# Grant Park Village Design Advice Request

## Case #EA 12-139539 DA

Date 8.16.12

Revised Signage Design

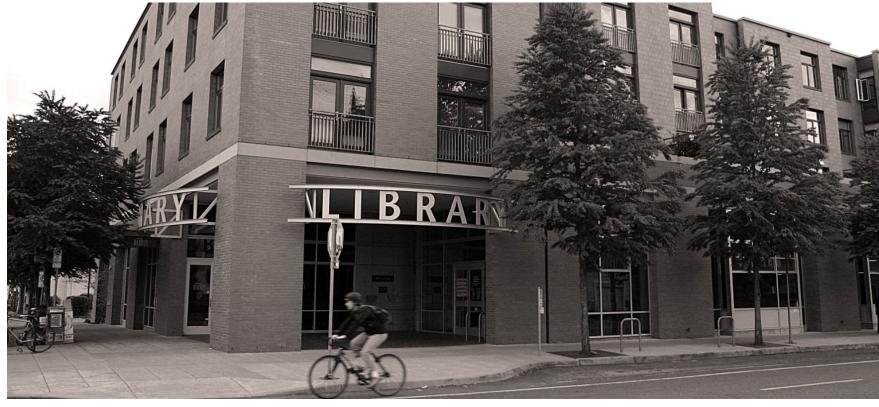
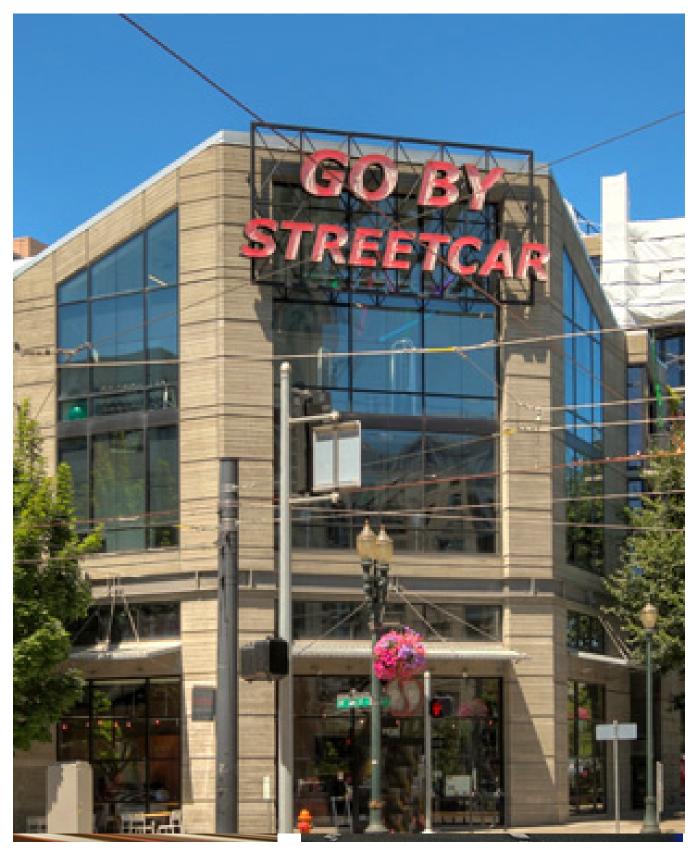
- •Create a sign package for retail tenants.
- •A signature sign facing the freeway is supportable if the sign is a wonderful, well-integrated sign.

- •Iconic sign integrated into building design
- •Easily identifiable from highway

## Revised Building Separation

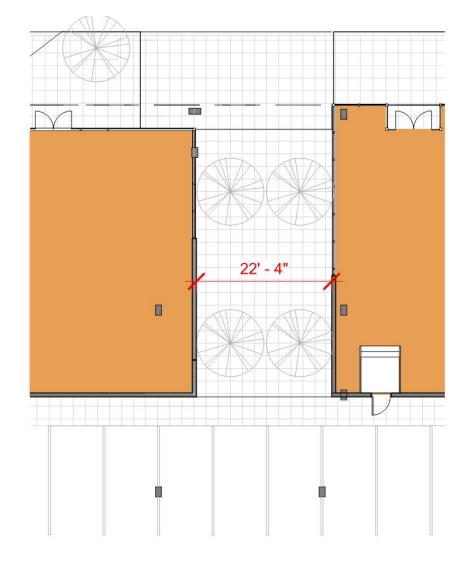
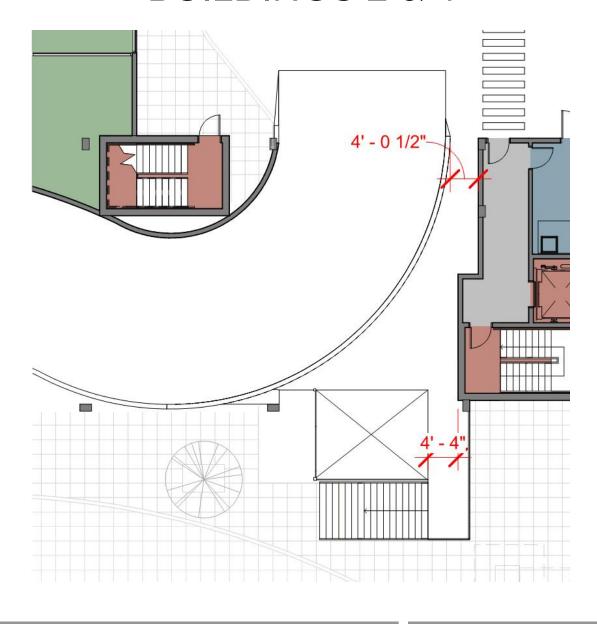
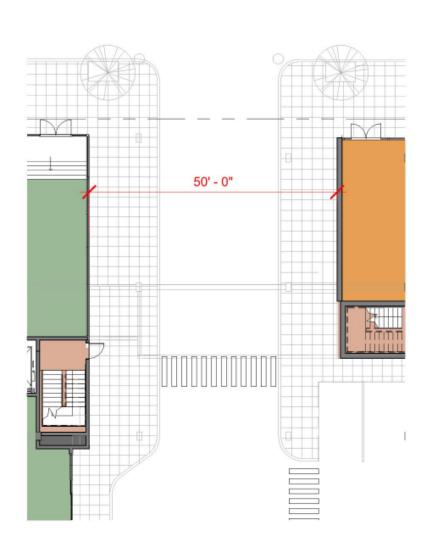
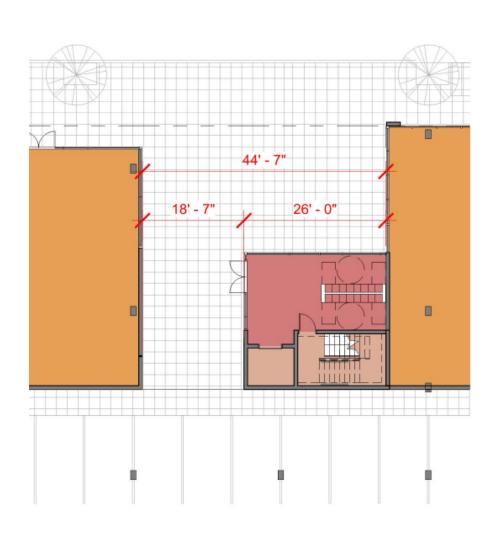
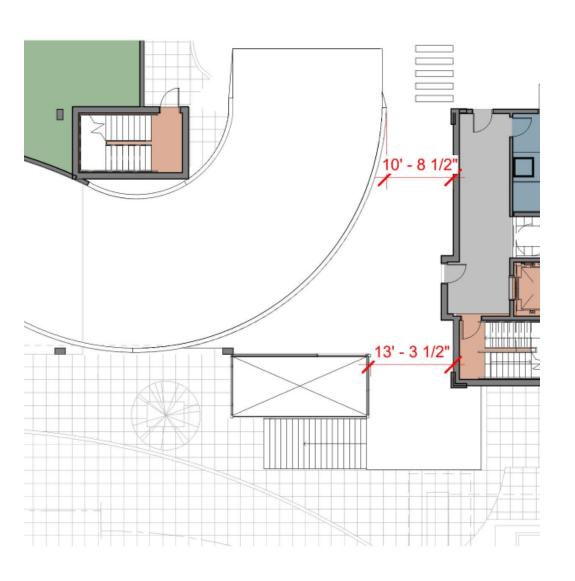
•More generous spaces between buildings to create an enhanced pedestrian experience

Revised Lower Level Floor Plan

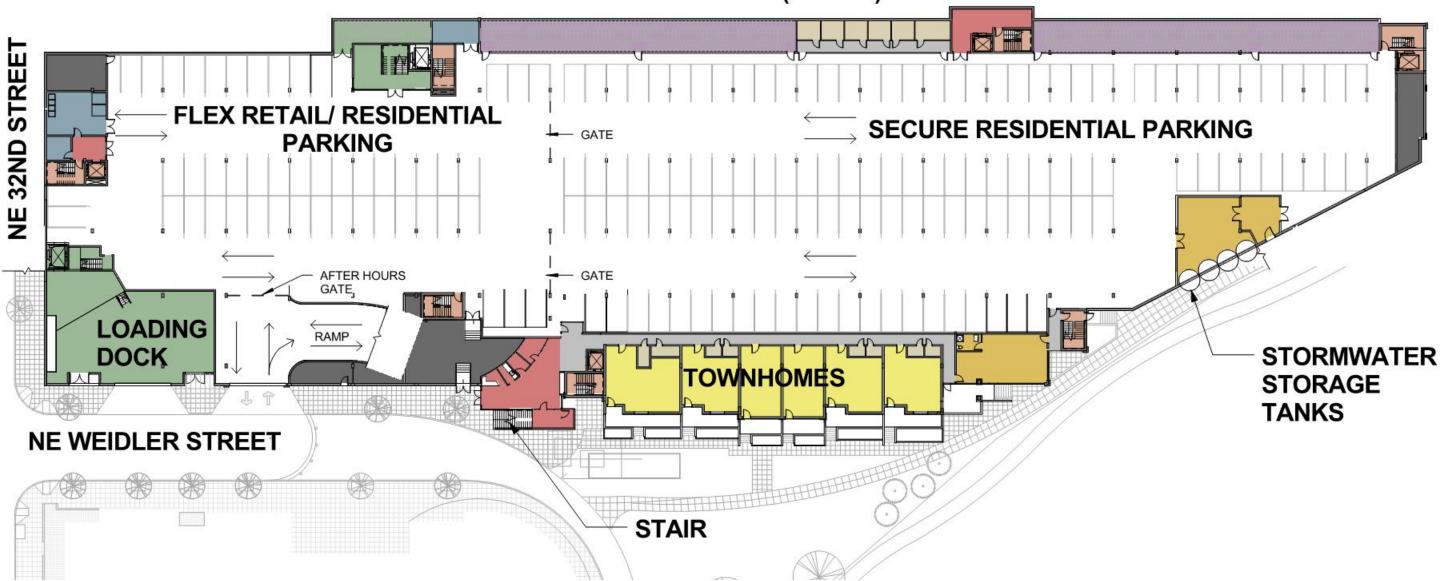
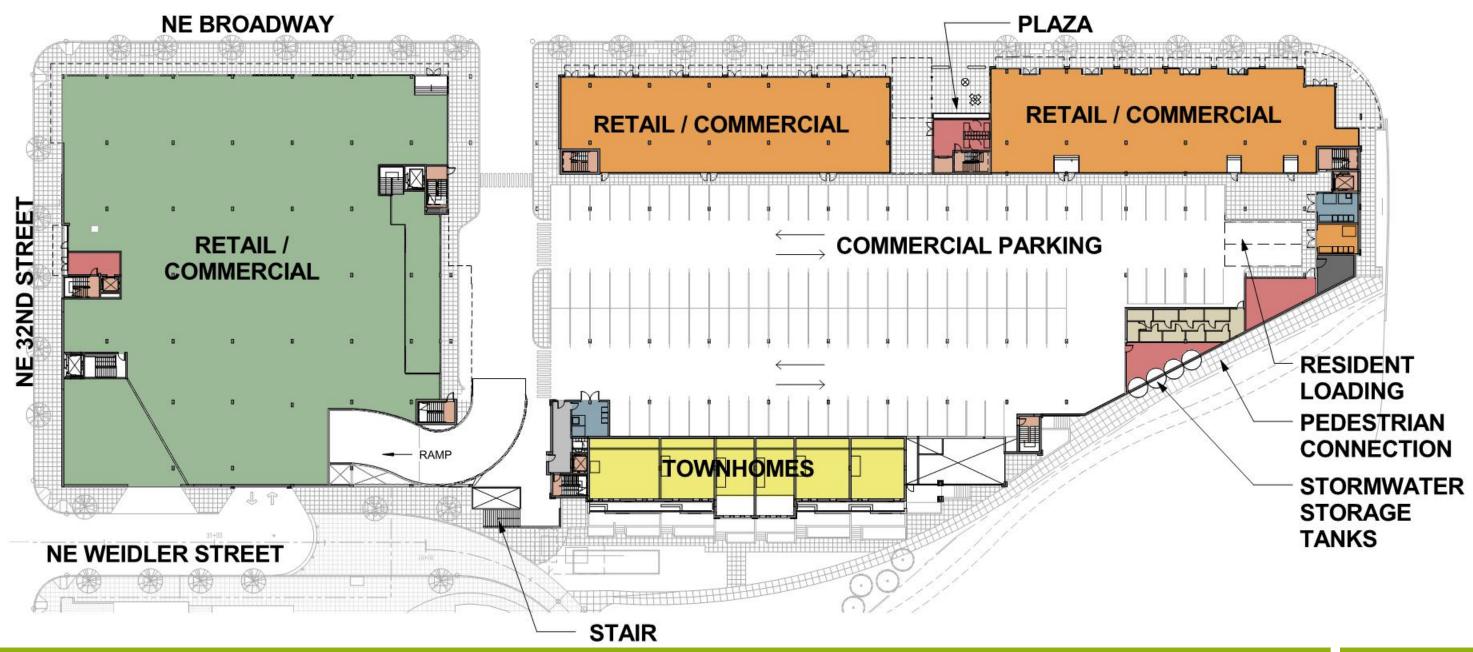
- •New residential lobbies extend to lower level to provide easy access to buildings above.
- •More generous leasing office provides a more significant presence on Weidler.
- Additional bike parking for retail tenant

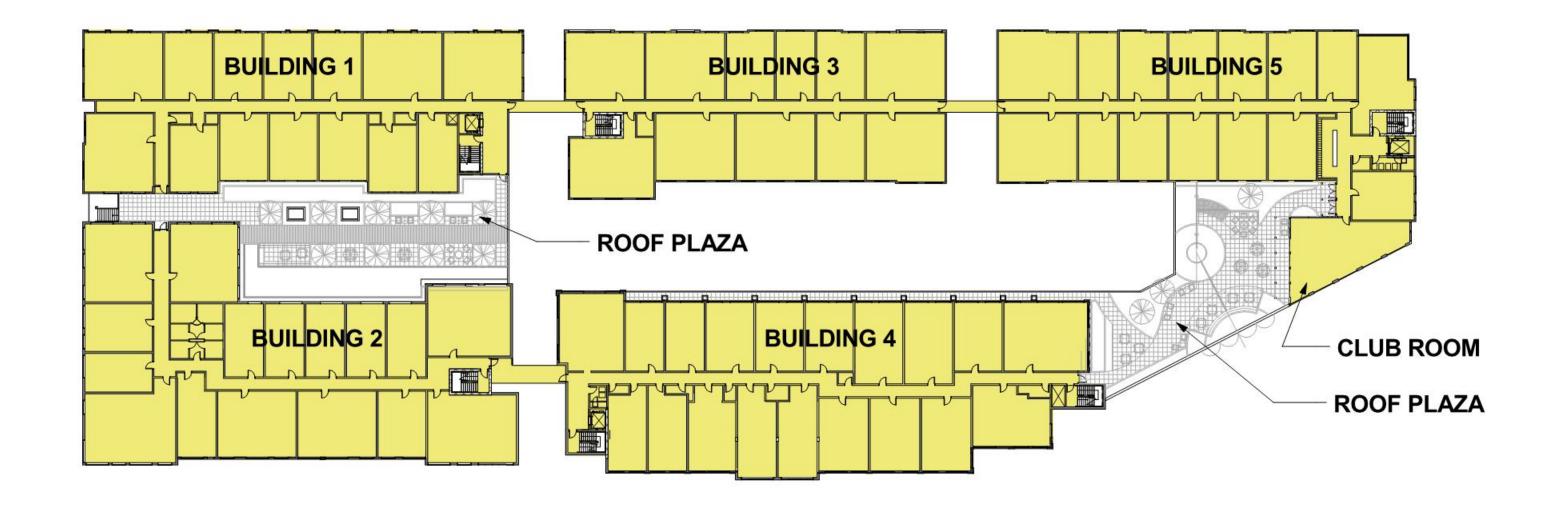
- •Widened pedestrian access between buildings and smaller building footprints
- •More generous pedestrian path from Broadway to Weidler, with a more open grand stair from Weidler

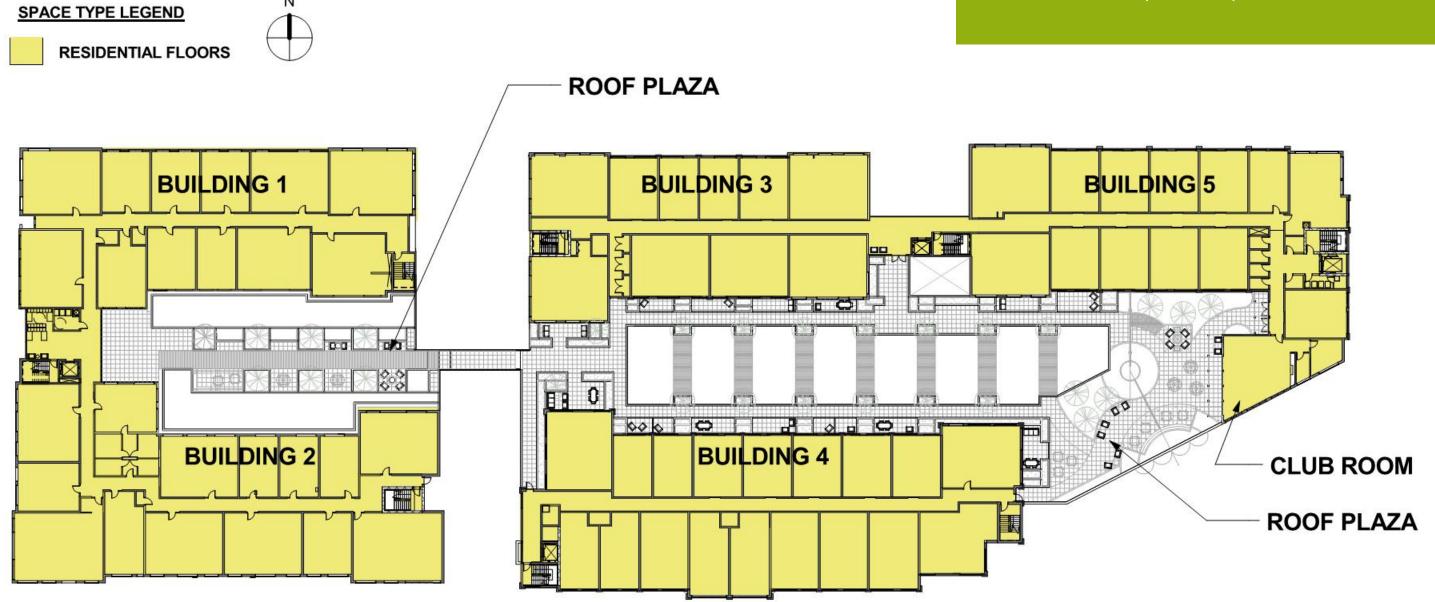
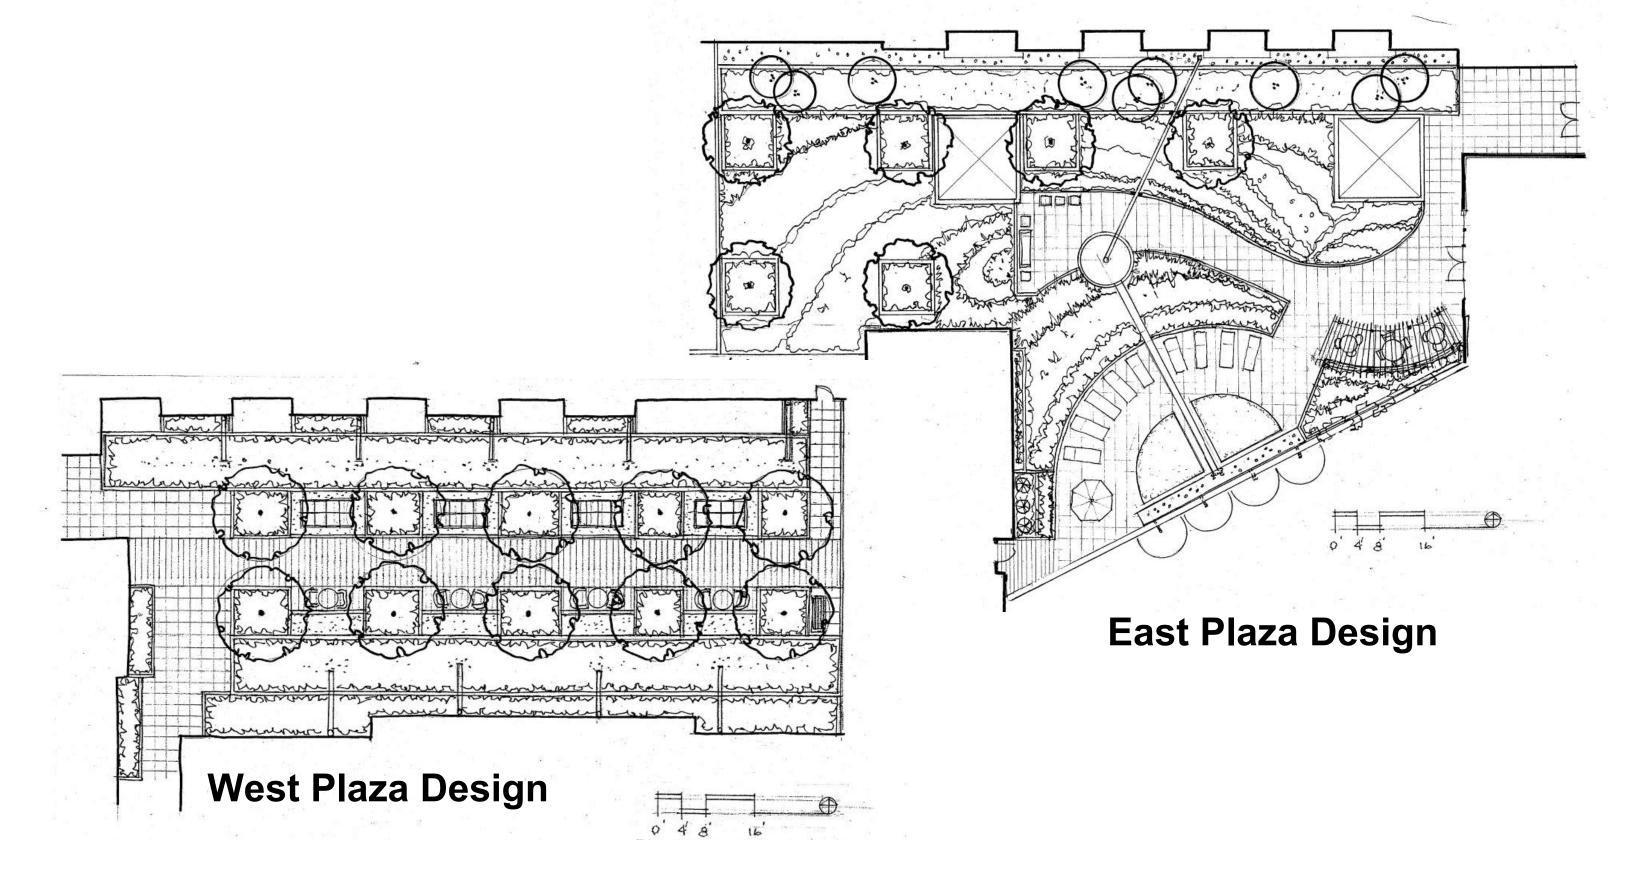
- •Village concept would be stronger without "air walks" Would like to see them go away.
- •Have Each building with it's own entrance from street.

- •Sky bridges removed.
- •Buildings connected above lobbies with glass corridors to provide visual break between buildings and new locations for vertical circulation
- Additional access points to plaza

Section – Looking East Thru Buildings 3 & 4 (N.T.S.)

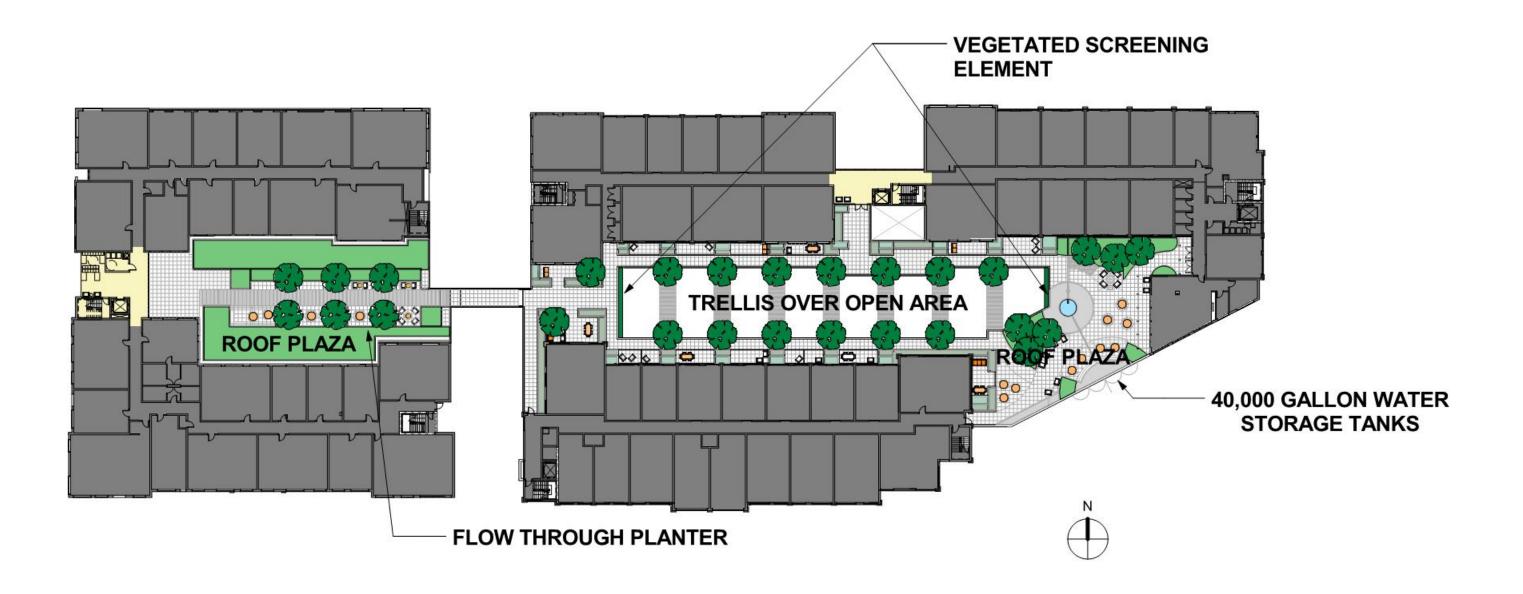
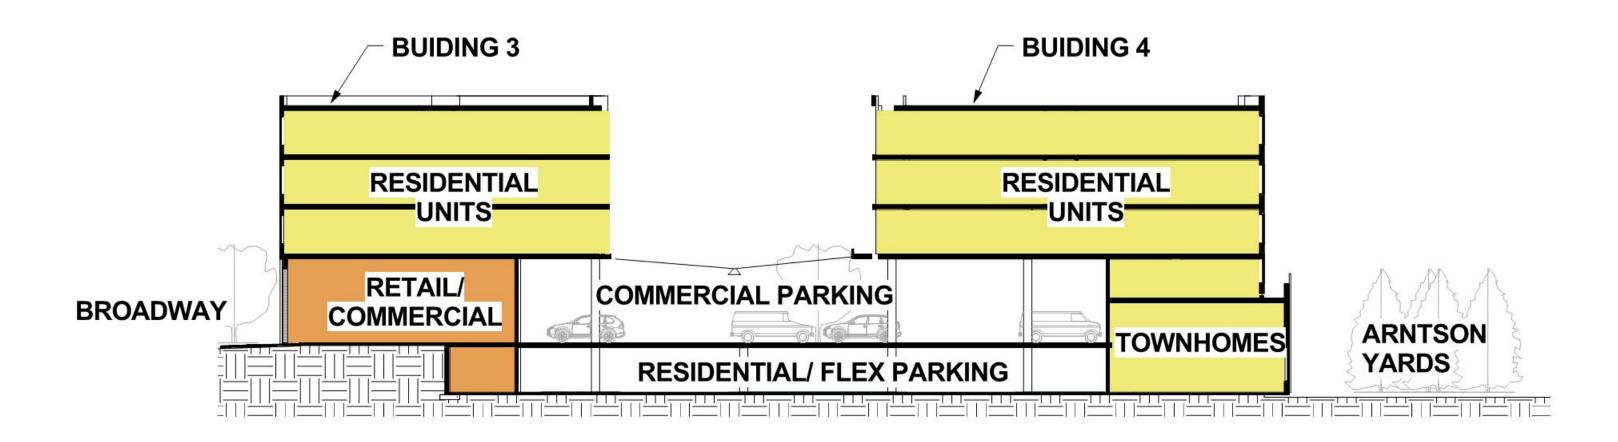
- •Beams with planting shield first floor parking from units above
- •Enlarged 2<sup>nd</sup> Floor Plaza creates a courtyard feel
- •Planters provide privacy between private patios and active plaza areas

Section – Looking East Thru Buildings 3 & 4 (N.T.S.)

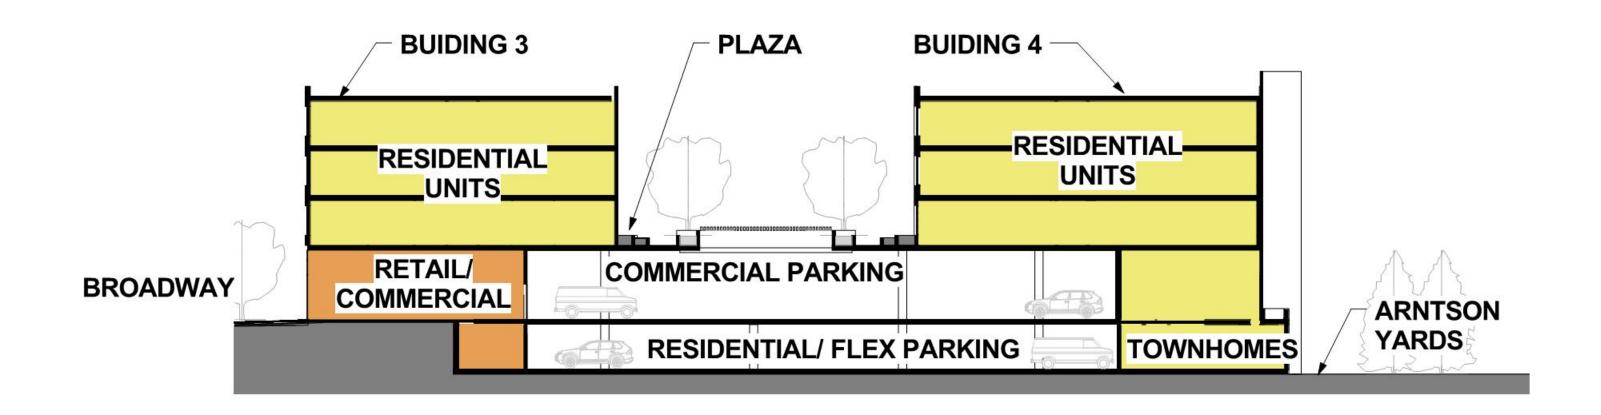
- •Beams with integrated planting shield first floor parking from units above, yet allow light to reach retail tenant parking below
- •Enlarged 2<sup>nd</sup> floor plaza creates a courtyard feel for upper floor residents

## Height Modification

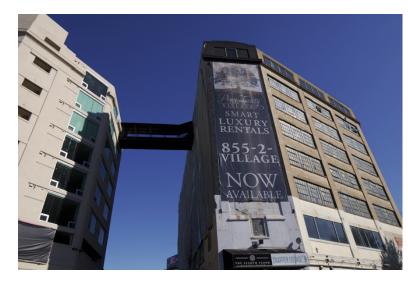
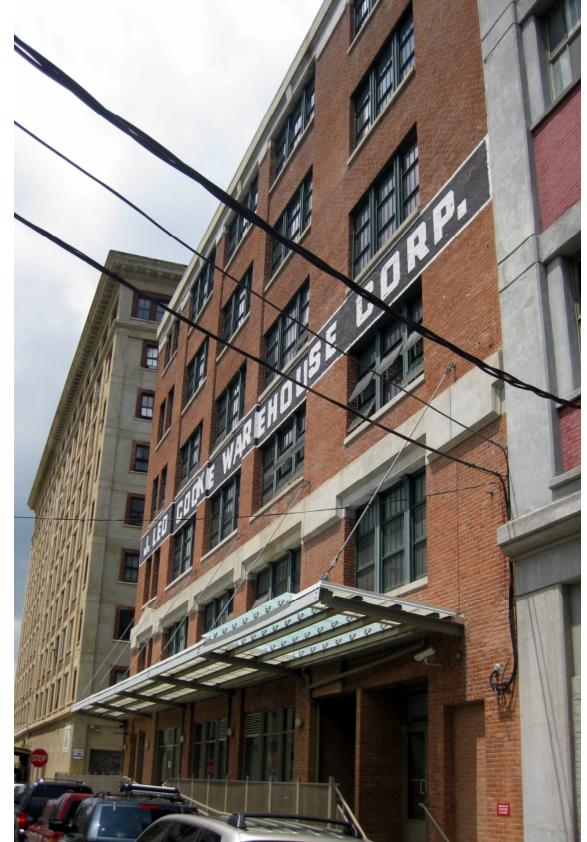
•Generally in support of a height modification if there is clear rationale for it.

- •The space between residential building volumes has been widened to allow more light into the interior plaza.
- •Bigger distance between buildings enhances their individual character and decreases the visual scale of the project on Broadway
- •Building height must increase to incorporate sufficient units into reduced footprint.
